MINUTE NO. 196

MODIFICATION OF THE ORIGINAL PLAN FOR THE
LOWER RIO GRANDE INTERNATIONAL FLOOD
CONTROL PROJECT.

JOINT REPORT OF THE PRINCIPAL ENGINEERS
RECOMMENDING MODIFICATION OF THE ORIGINAL PLAN FOR THE
LOWER RIO GRANDE INTERNATIONAL FLOOD CONTROL PROJECT

INTERNATIONAL BOUNDARY & WATER COMMISSION
UNITED STATES & MEXICO
LOWER RIO GRANDE FLOOD CONTROL PROJECT
ANZALDUAS DIVERSION DAM
PLAN AND SECTIONS

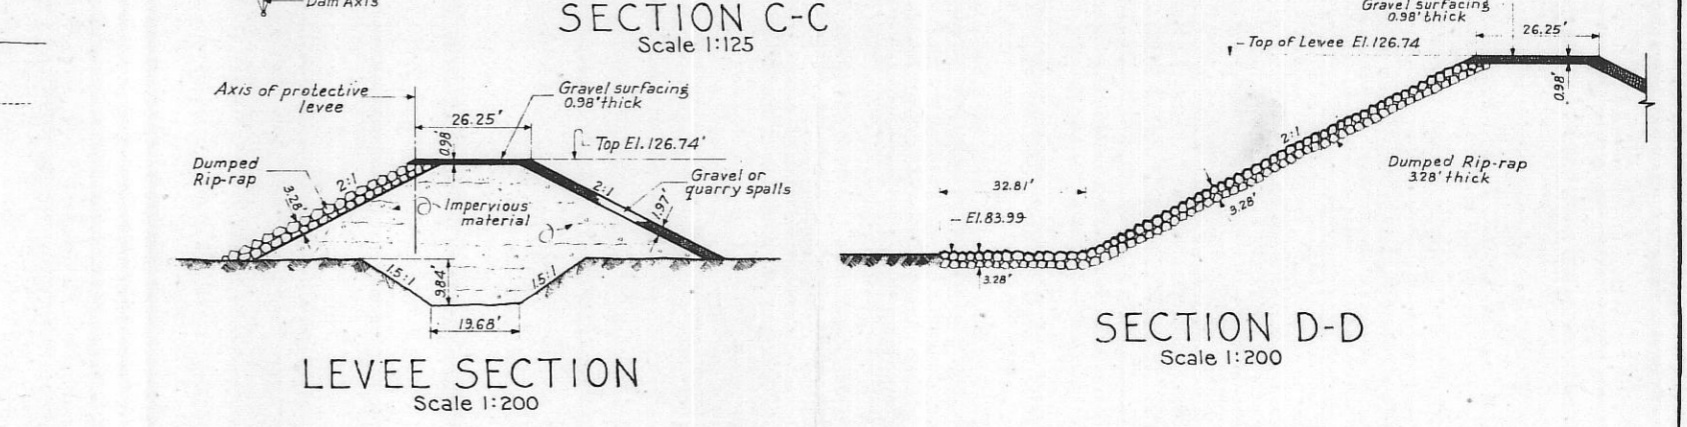
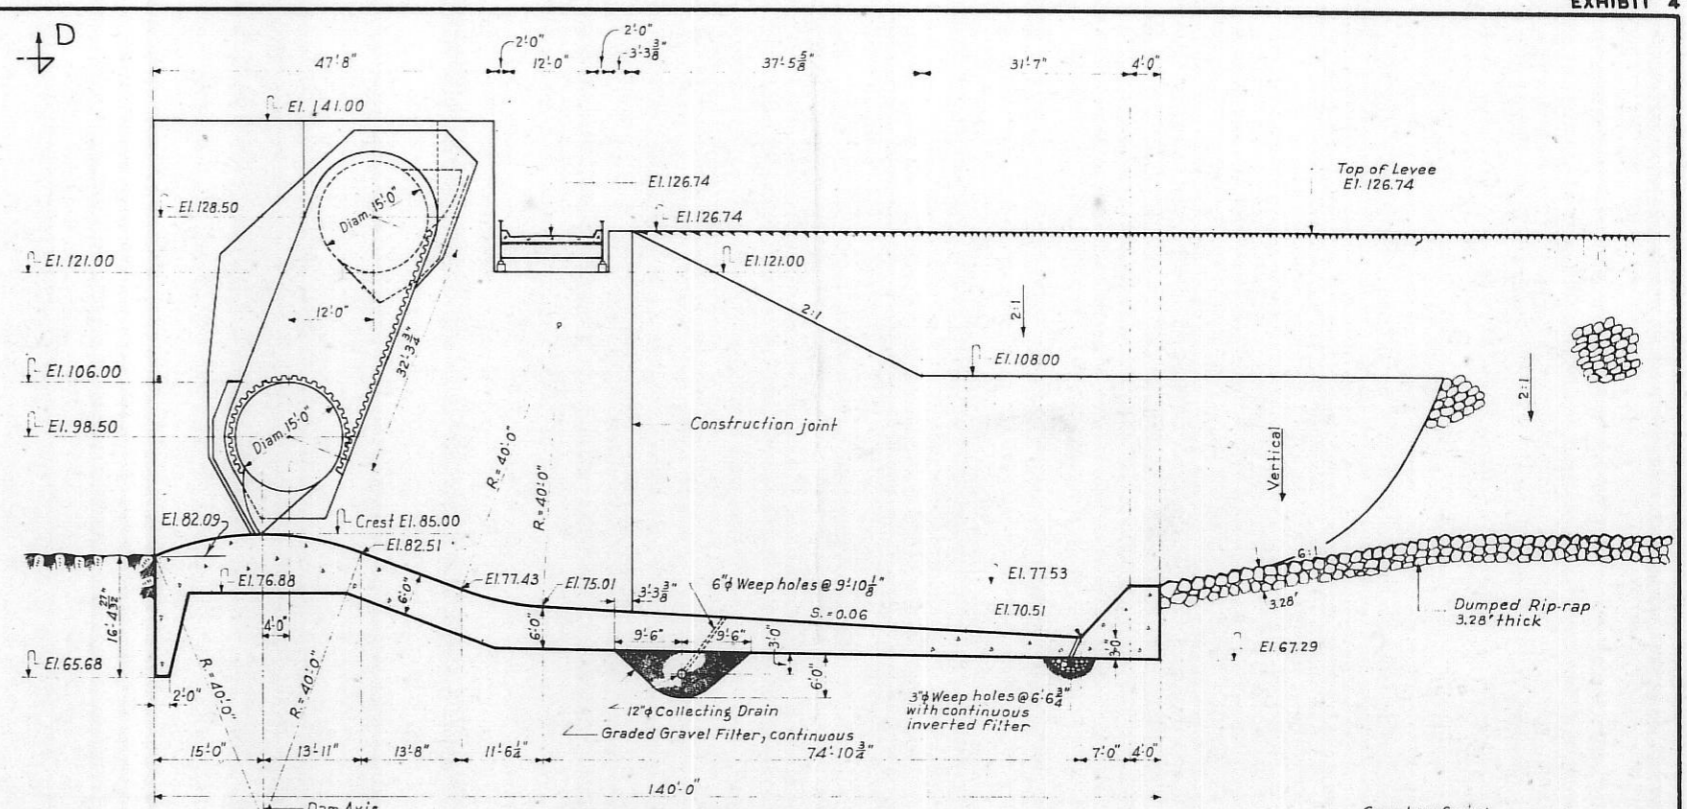
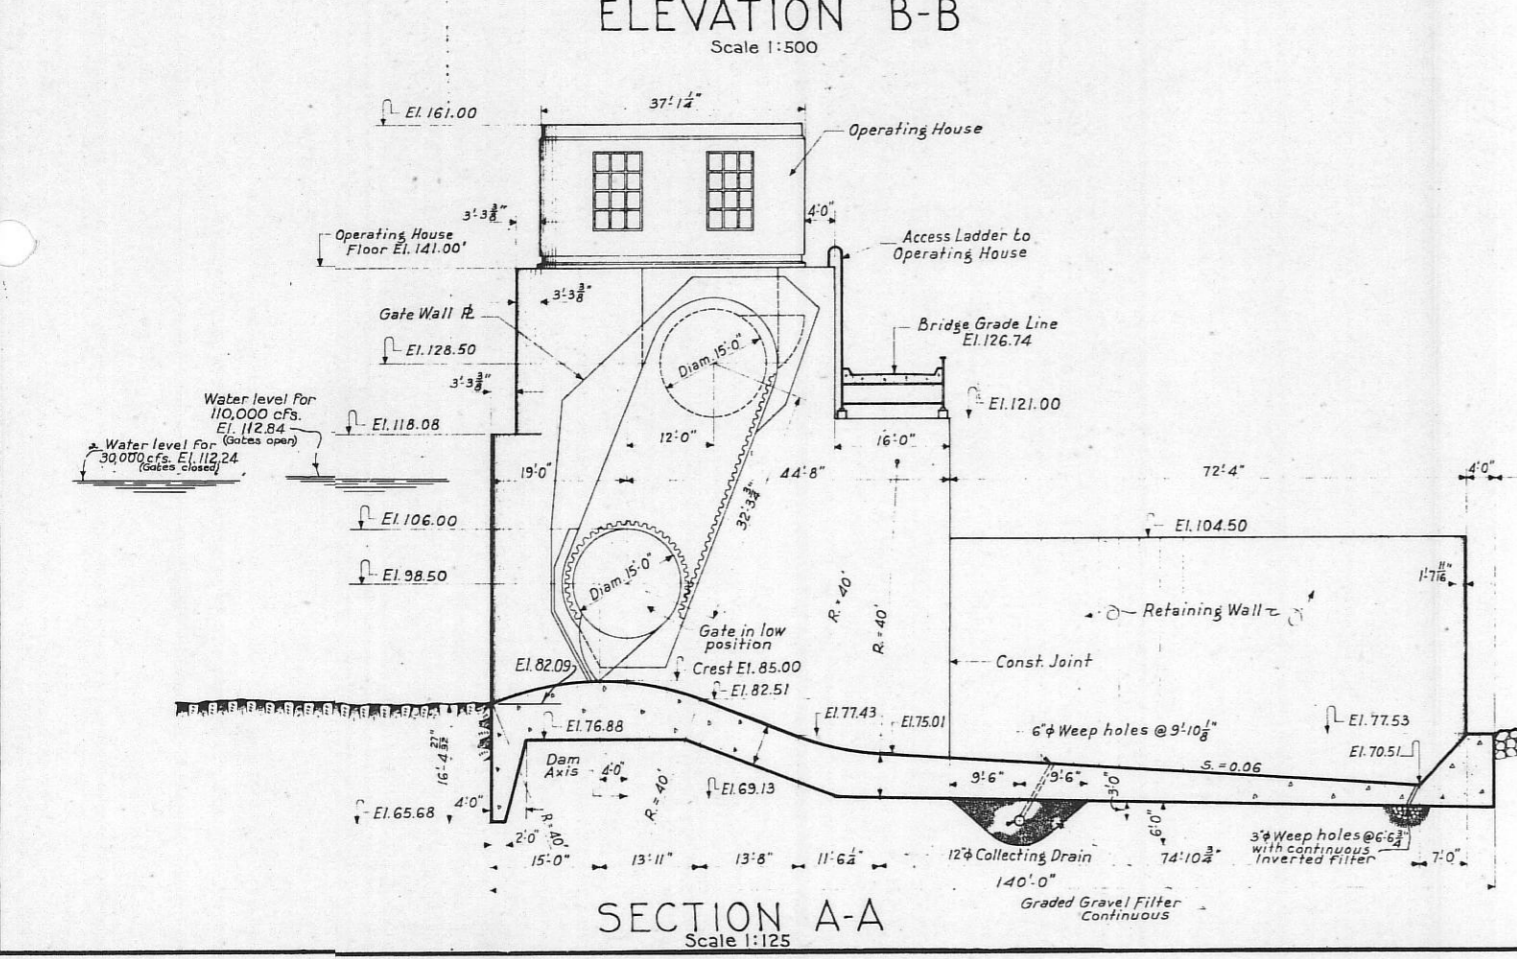
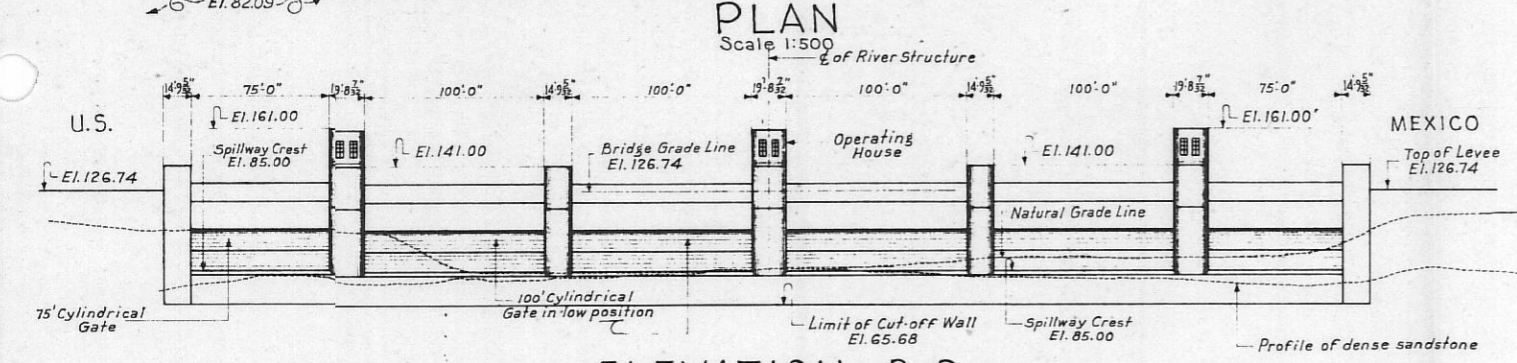
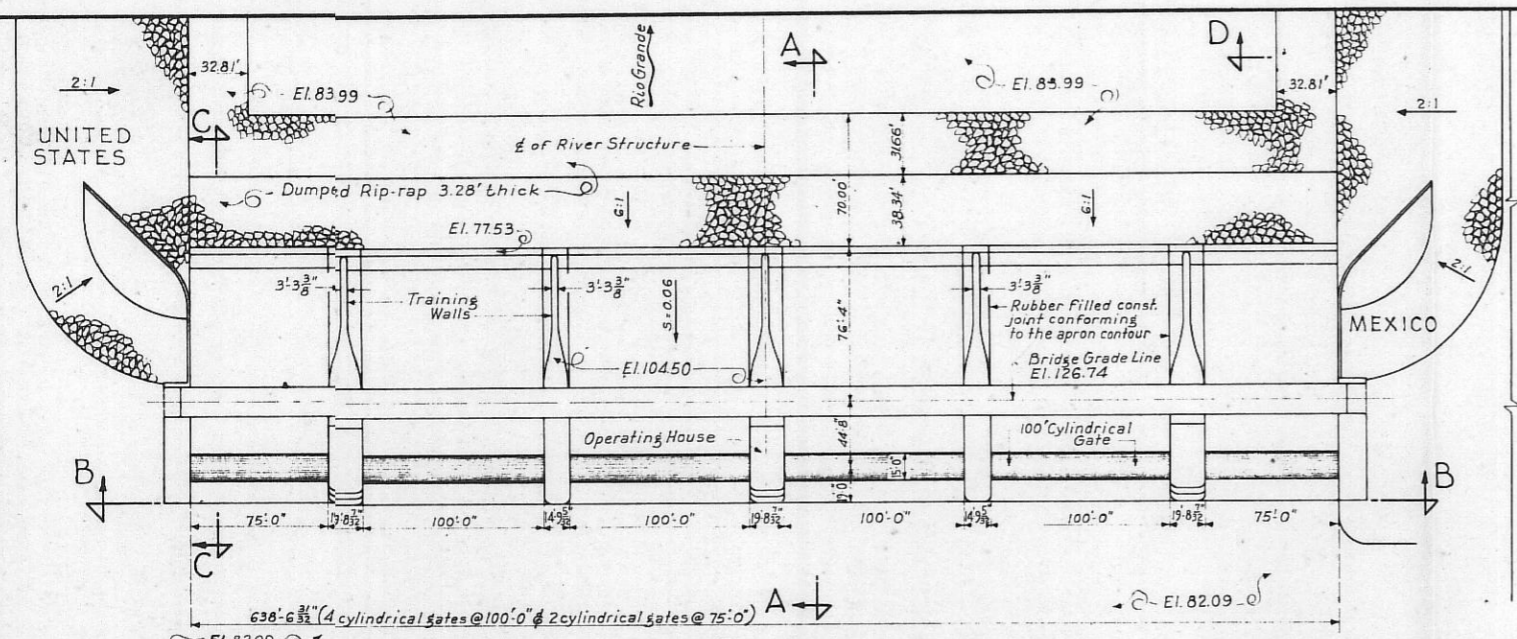
A preliminary drawing, "Anzaldúas Diversion Dam - Plan and Sections", is shown in Exhibit No. 4. The dam is a concrete structure founded on sandstone with the gate sill located 1 foot above the present river bottom, and
with

with training dikes on both ends of the structure. The structure will be 640 feet between abutments and 140 feet in length along the river. Control is furnished by four roller gates, each 15 feet in diameter, with a 6-foot lip, and 100 feet long. The crest of the roller gates in a closed position will be at elevation 106.00. The total travel of the roller gates from closed to fully open position is 32.15 feet, and in fully open position the gates will clear the maximum high water surface by 5 feet. Immediately adjacent to the main gate on each side is a roller sluice gate 75 feet in length. A service bridge with 12-foot roadway is provided along the downstream part of the piers. Hoist houses are provided on the piers on which the machinery for raising the roller gates will be installed. The stilling basin below the gates is designed so that the hydraulic jump will be contained within the basin even under the most adverse condition which is assumed to be that with one gate partially open and with headwater at the top of the other three gates. Below the stilling basin 70 feet of riprap paving will be installed in the river channel section. The plan of the dam is such that either country may readily install irrigation diversion facilities above the structure. Further design studies may show that revisions should be made in the plans for the gates and in the shape of the lining below the gates.

LOWER RIO GRANDE FLOOD CONTROL PROJECT
 RIO GRANDE
 PENITAS-REYNOSA VIEJO TO HIDALGO-REYNOSA
 WATER SURFACE PROFILES

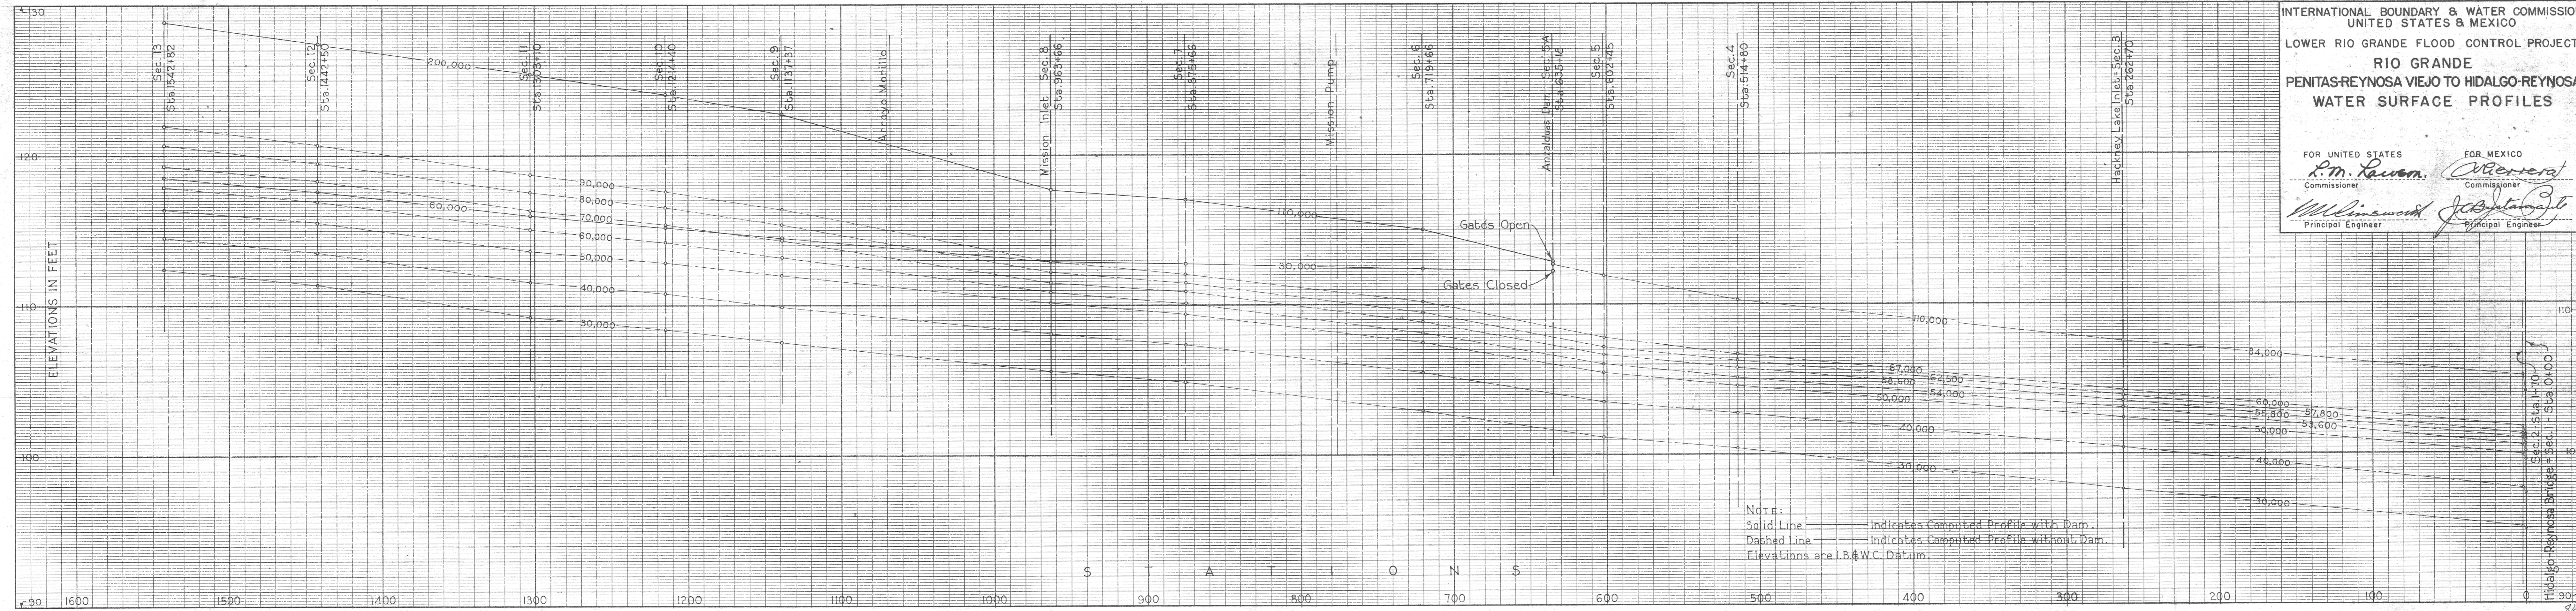
The backwater surface for both the 60,000 second-foot and the 200,000 second-foot floods have been computed and are shown in Exhibit No. 5, "Rio Grande - Peñitas-Reynosa Viejo to Hidalgo-Reynosa - Water Surface Profiles".
